Final Product/Process Change Notification

Document #:FPCN23449XB

Title of Change:	Assembly and Test Transfer from AUK Dalian, China to JCET CHUZHOU, China for TO92 Products, Case Outline 29-11 Change for TO92 Products.
Proposed First Ship date:	20 Mar 2022 or earlier if approved by customer
Contact Information:	Contact your local onsemi Sales Office or Jireh.Dulla@onsemi.com
PCN Samples Contact:	Contact your local onsemi Sales Office or PCN.Support@onsemi.com Sample requests are to be submitted no later than 30 days from the date of first notification, Initial PCN or Final PCN, for this change. Samples delivery timing will be subject to request date, sample quantity and special customer packing/label requirements.
Additional Reliability Data:	Contact your local onsemi Sales Office or Lalan.Ortega@onsemi.com
Type of Notification:	This is a Final Product/Process Change Notification (FPCN) sent to customers. FPCNs are issued 90 days prior to implementation of the change. onsemi will consider this change accepted, unless an inquiry is made in writing within 30 days of delivery of this notice. To do so, contact PCN.Support@onsemi.com

Description and Purpose:

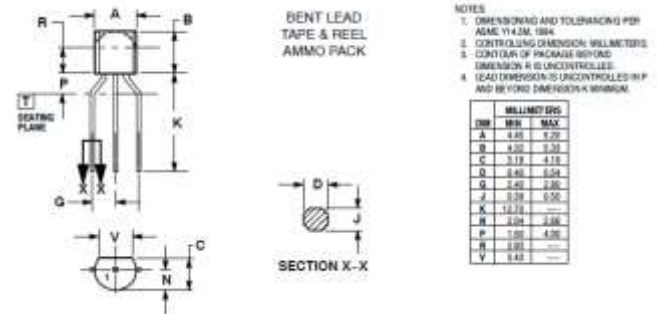
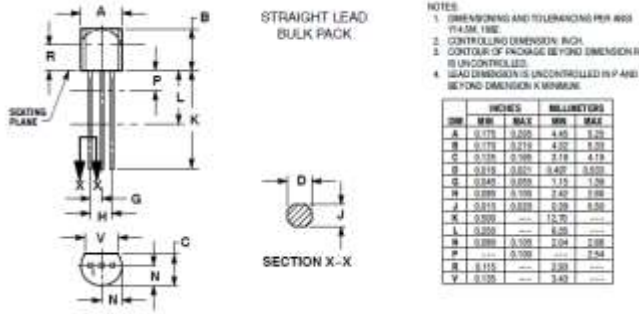
onsemi would like to inform customers of the intent to transfer assembly and test for the TO92 products listed in this notification from the current site, AUK Dalian, China to JCET CHUZHOU, China. BOM (Bill of Materials) changes are listed below:

Before Change Description	After Change Description
LeadFrame	KDMM-B005(95X95 MIL C/G TO-92 AUK)	LF TO92L 3L CuAg STAMPED
Die Attach	ABLE843-001(EPOXY ABLE STICK)	ABLEBOND 84-3J
Mold Compound	7EMC1040(HFMOLD COMPOUND EME-E120G)	EMG-460-3
Assembly Site	AUKD	JCET China

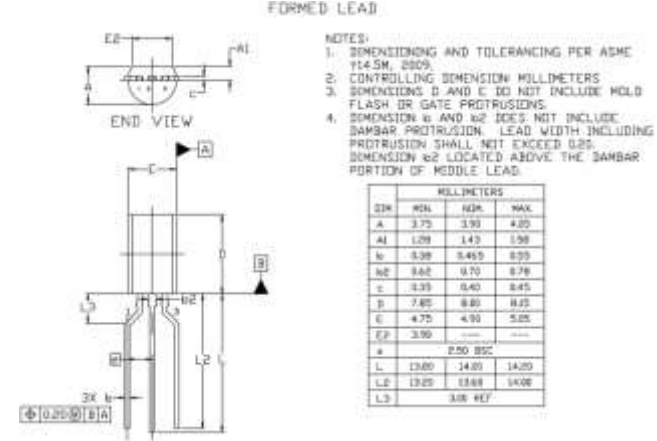
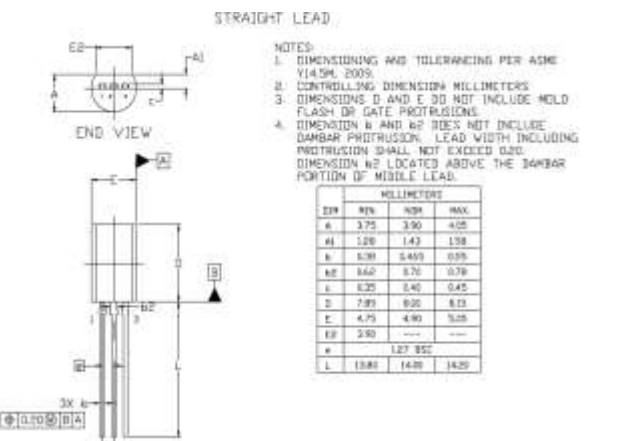
Product marking changes are shown here:

From	To
Product marking change	Trace Code Assembly Location Line 3: W(LYW) L: Wafer Lot Number YW: Assembly Start Week	Trace Code Assembly Location Line 3: JC(LYW) L: Wafer Lot Number YW: Assembly Start Week Note: No Pb Free Microdot
